Request for Administrative Amendment Approval

RE: U-HAUL – 4TH AND I-40
REQUEST FOR ADMINISTRATIVE AMENDMENT
2217 4TH STREET NW ALBUQUERQUE, NM 87107
TR C OF ALEXANDER CENTER (EXCL S'LY PORT OUT TO R/W)
ZONE ATLAS PAGE H-14-Z

Tierra West, LLC, on behalf of U-Haul, requests approval for an Administrative Amendment to the Site Development Plan for the above referenced project. The project is located at 2217 4th Street NW, Albuquerque, NM 87107. The request is to revise the loading dock area from two docks to one dock as shown on the attached revised Traffic Circulation Layout.

DRB SITE PLAN

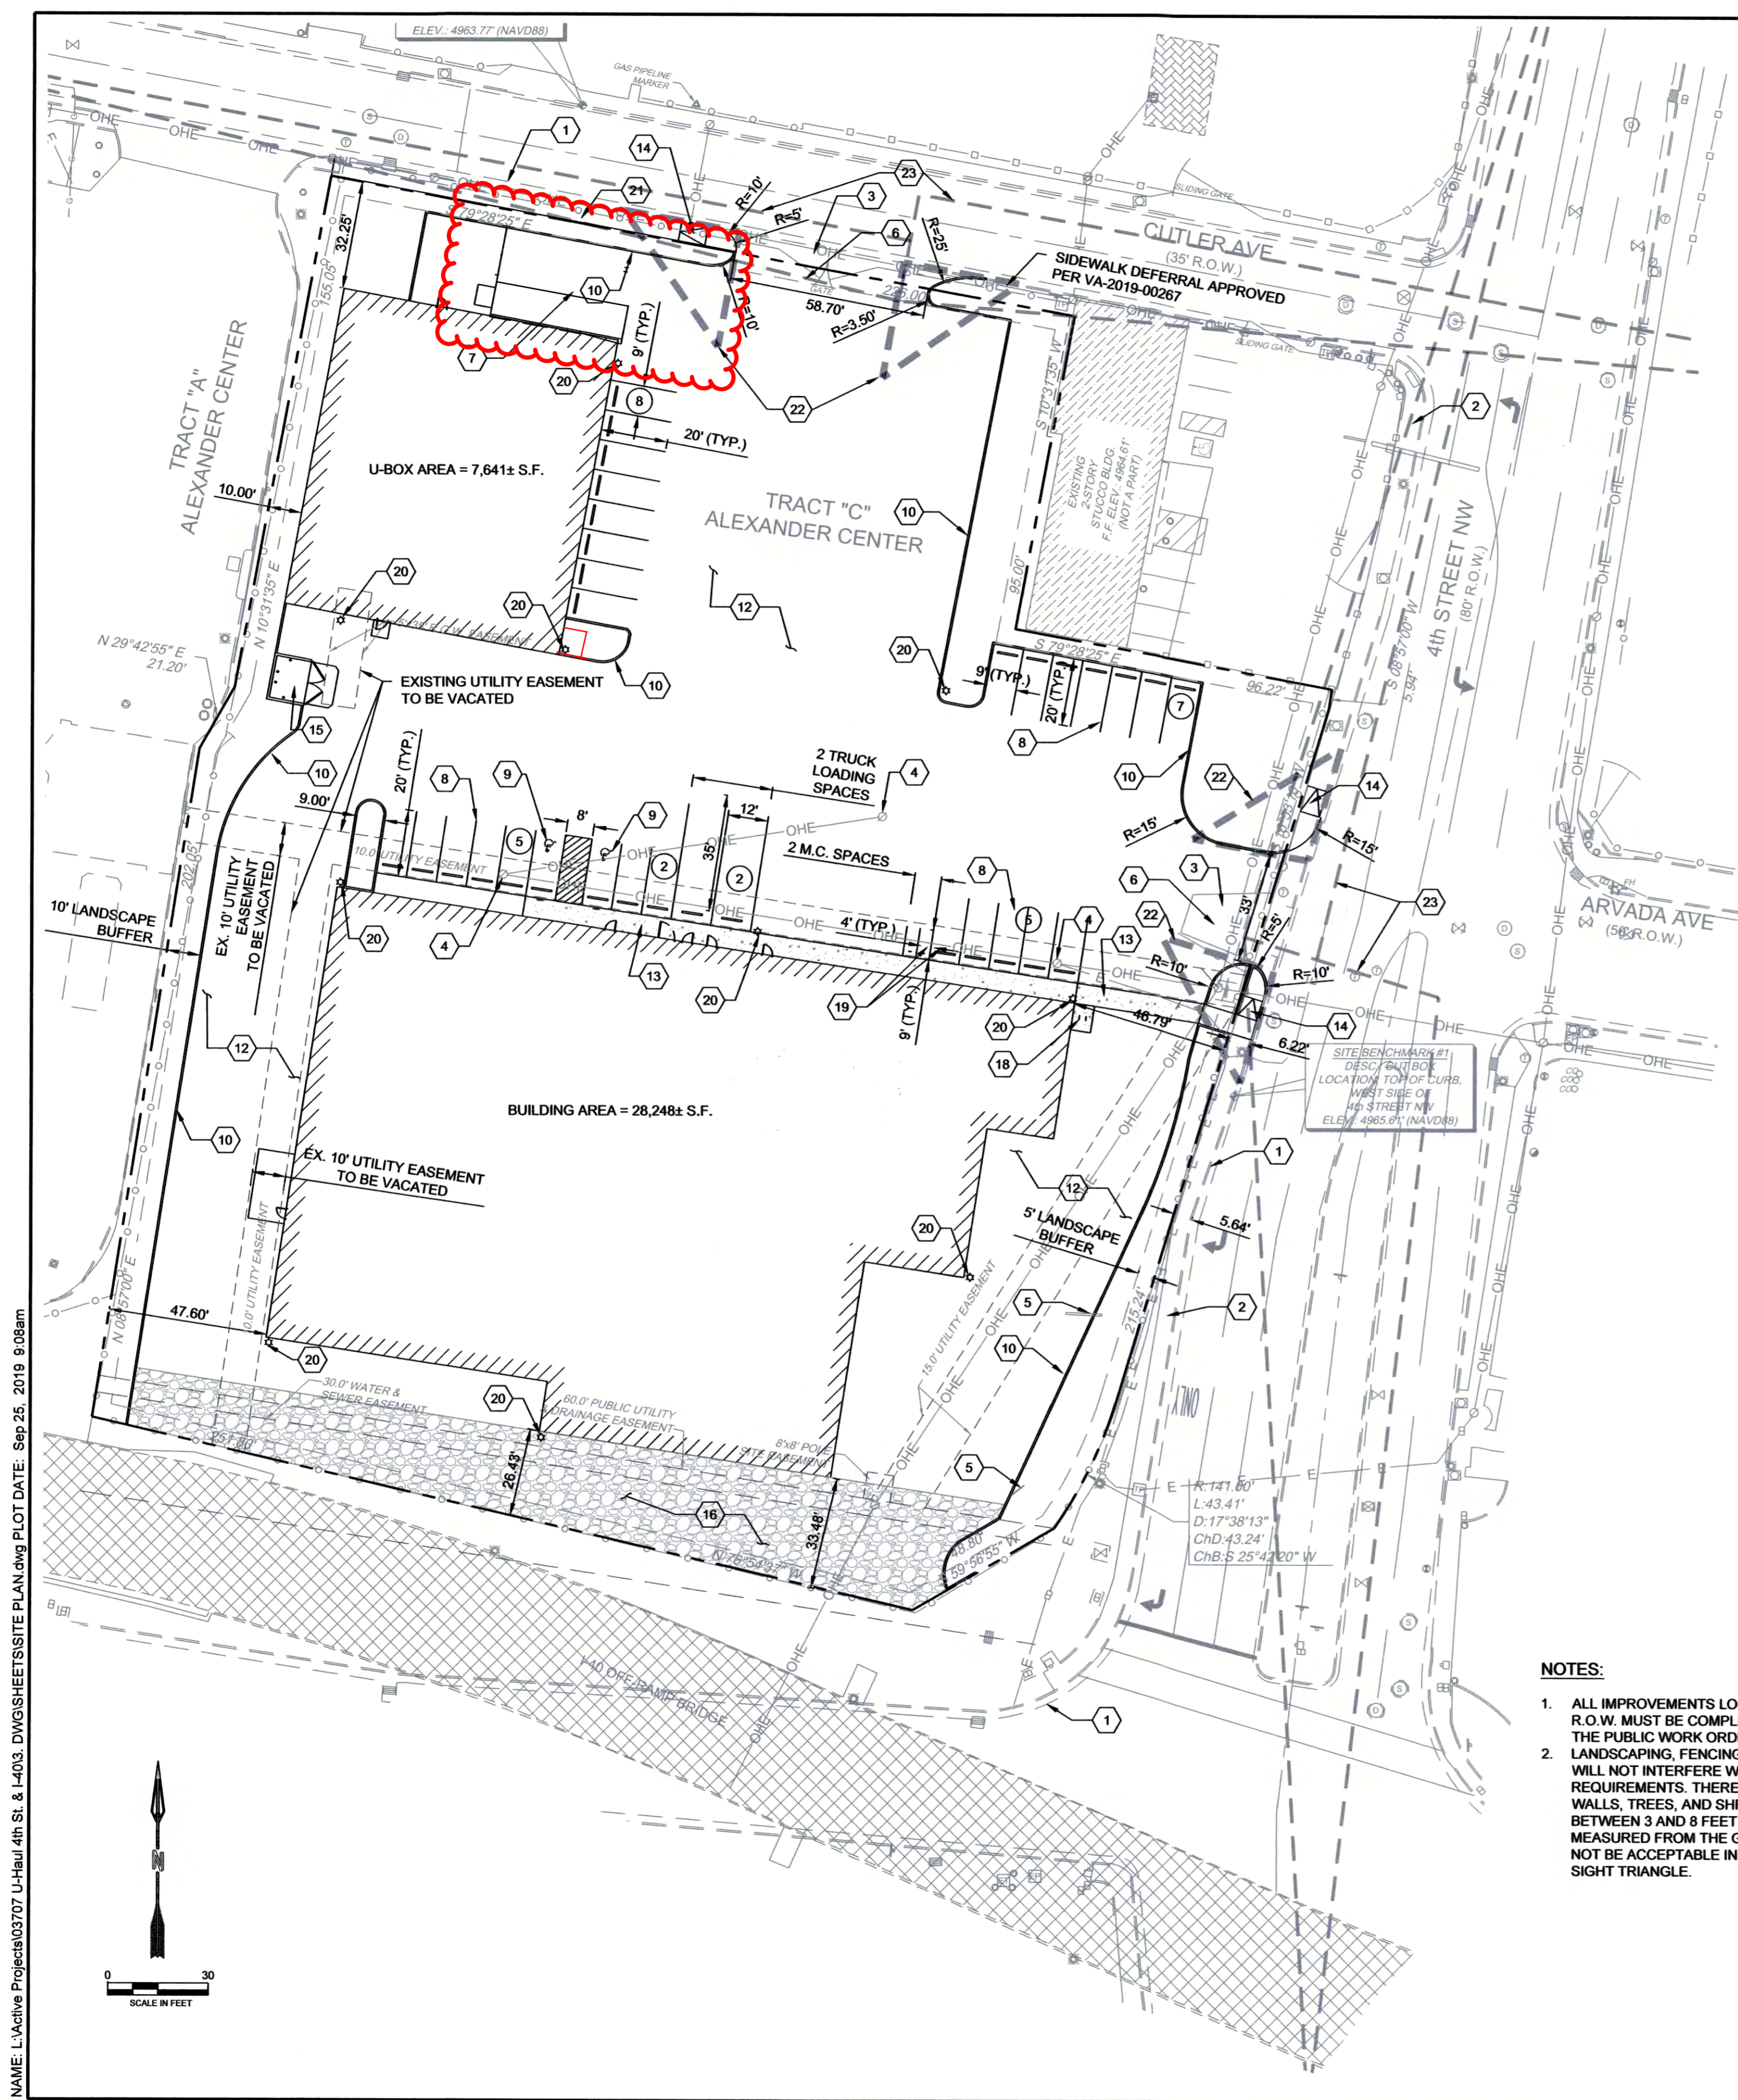
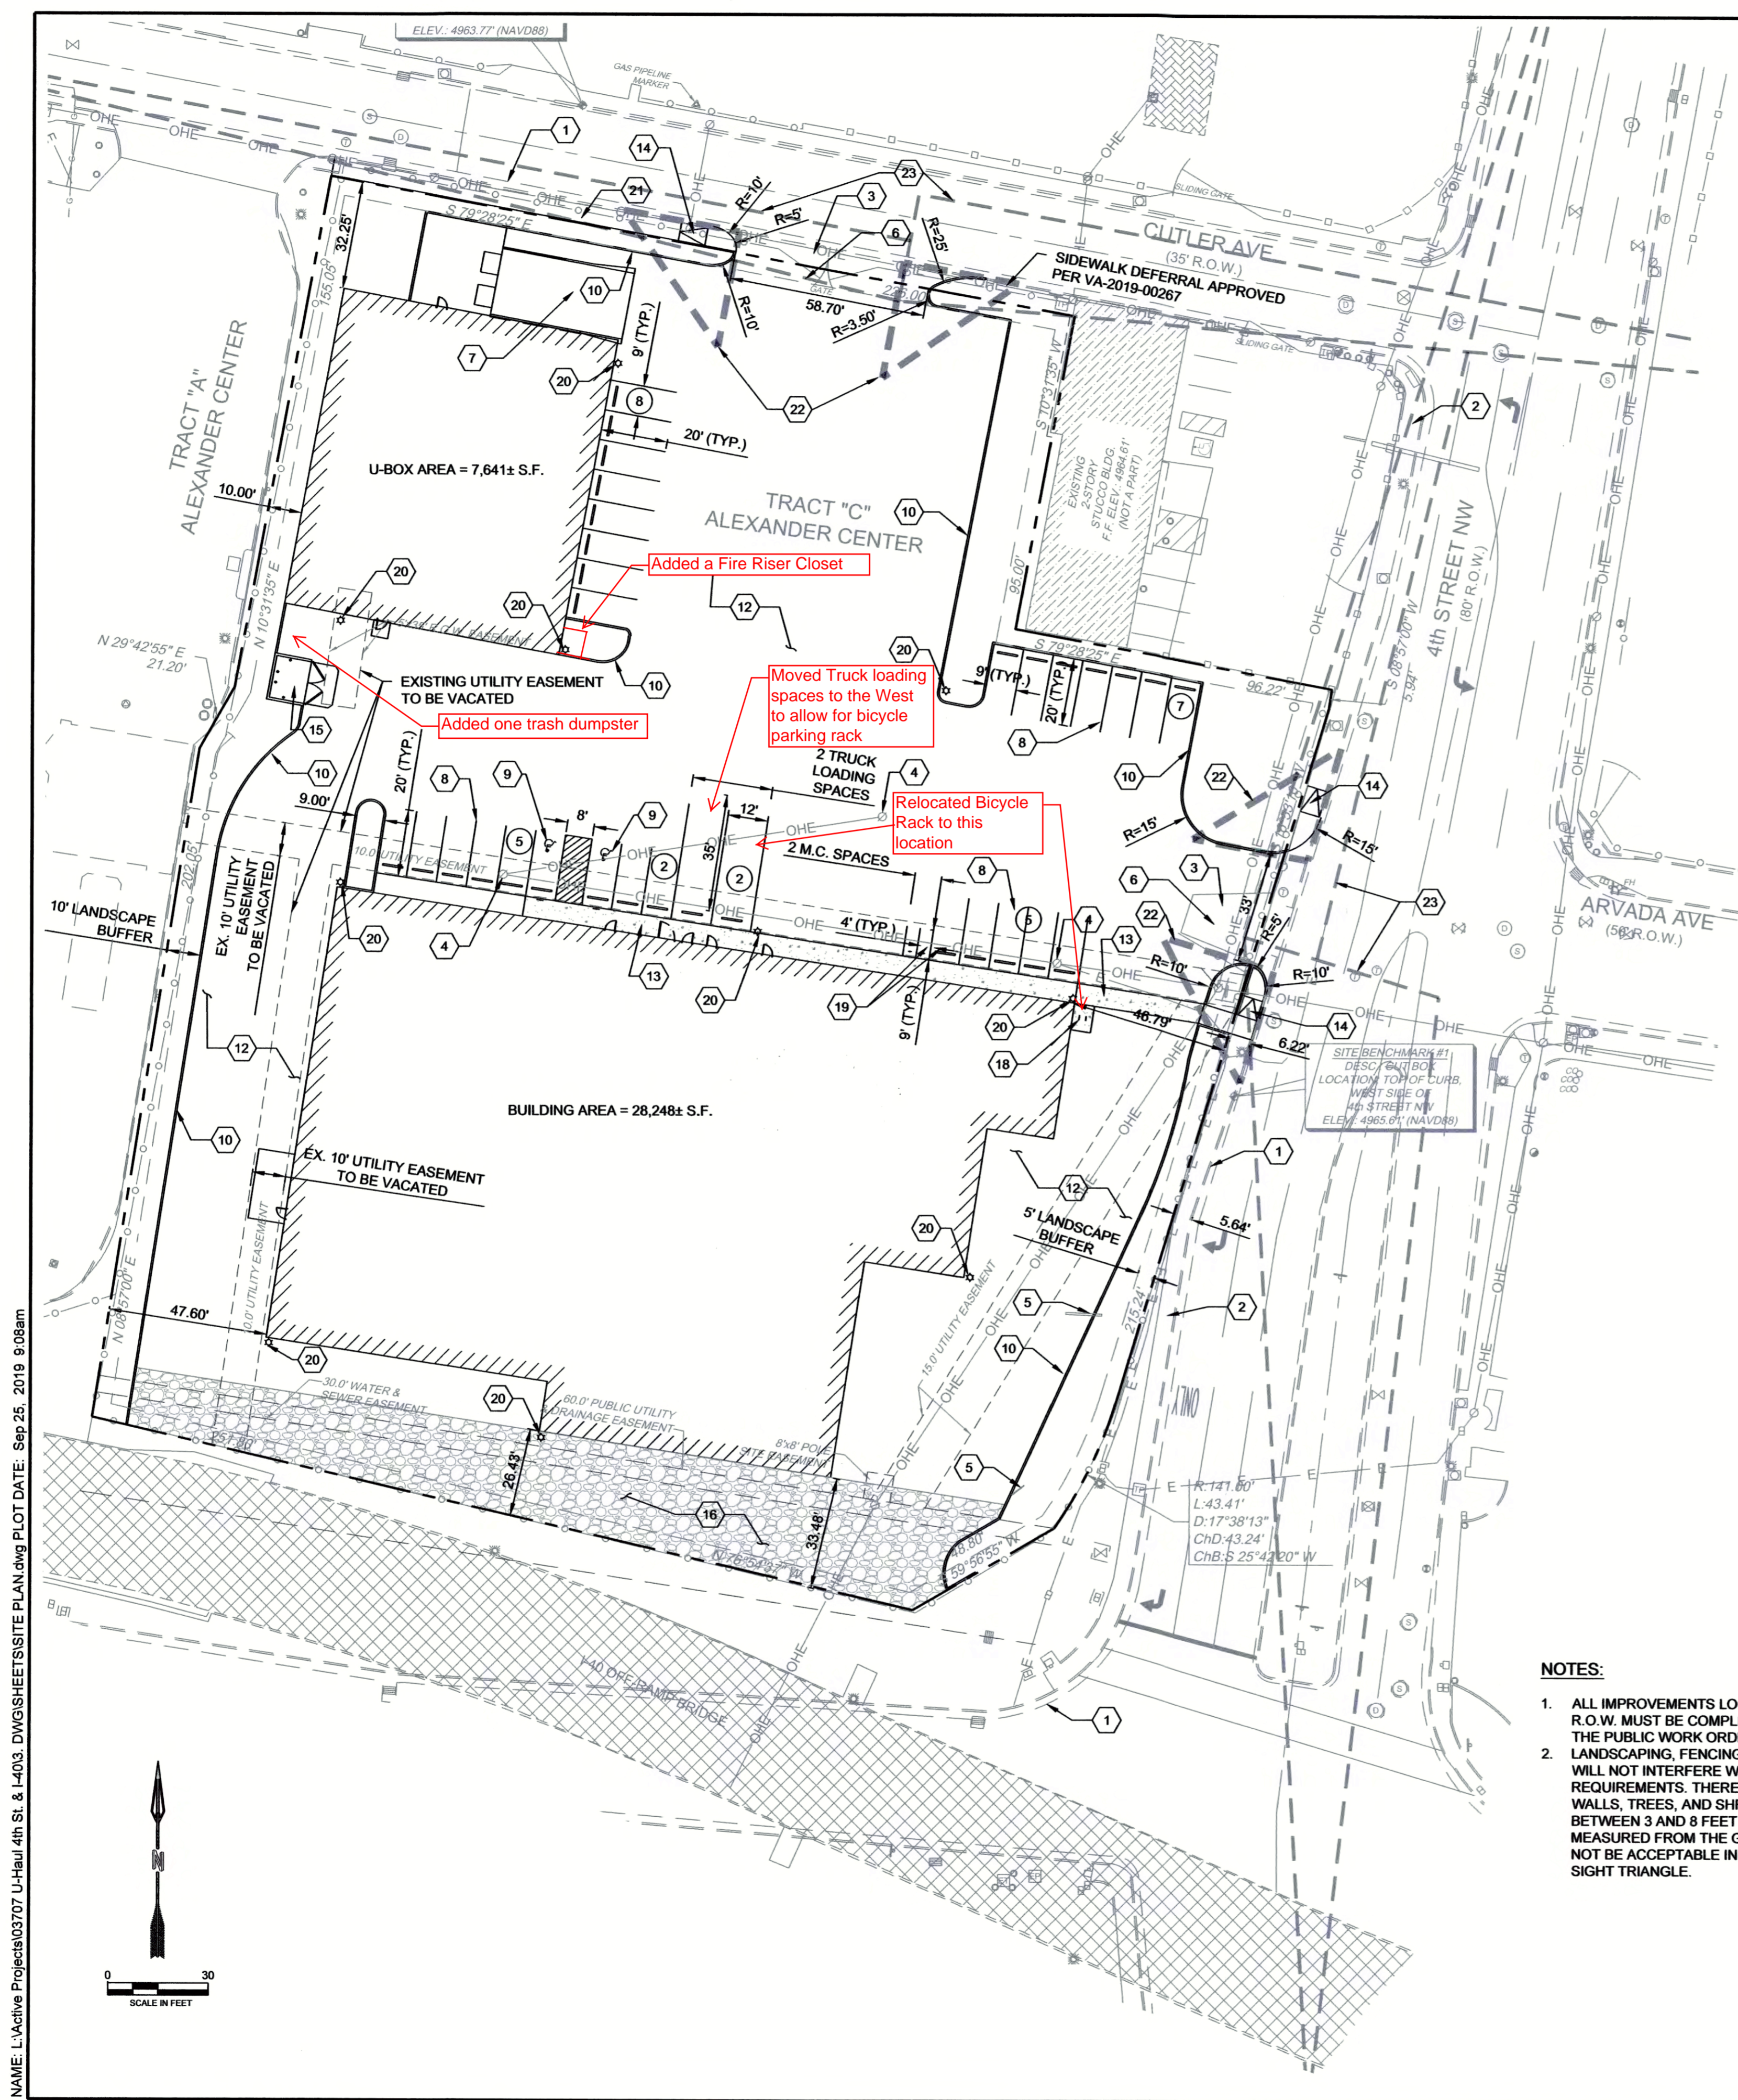
This project construction was delayed due to the COVID Pandemic and during that period market conditions dictated the need for only one loading dock. The asphalt area north of the single dock will be an at grade forklift access to the dock area. Attached is the approved Site Plan for Building Permit Plan that we would like to amend to show the single loading dock.
